TROLLEY MODIFICATION

Modification of 6 BMW trolleys to VW270 MQB pans trolley.

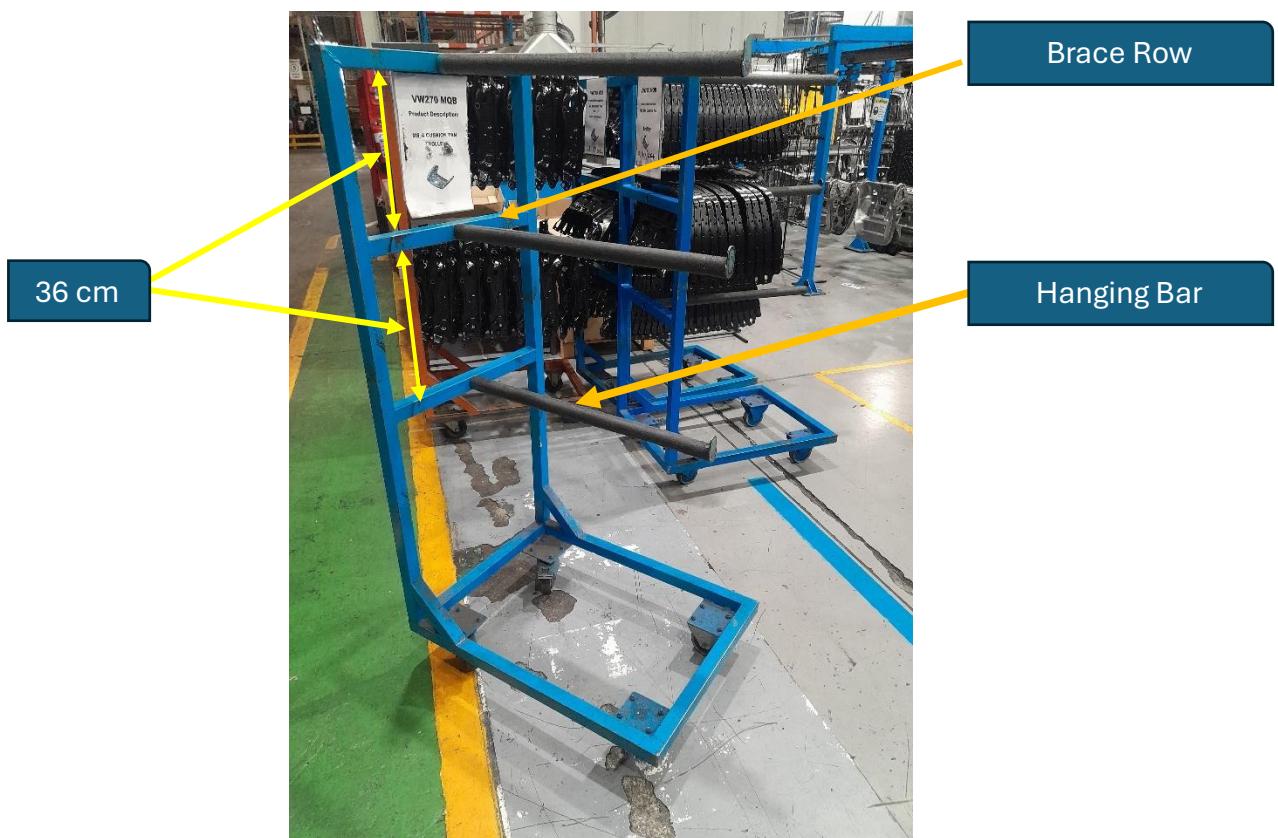
1. **Remove Hanging Bars:** Detach the 4 hanging bars from the sides of each of the 6 BMW trolleys.
2. **Weld :** Weld 1 bar at the centre of each row. The BMW trolley has 2 brace rows that must be changed to three rows.
3. **Spacing:** Ensure a 36 cm gap between each row vertically.
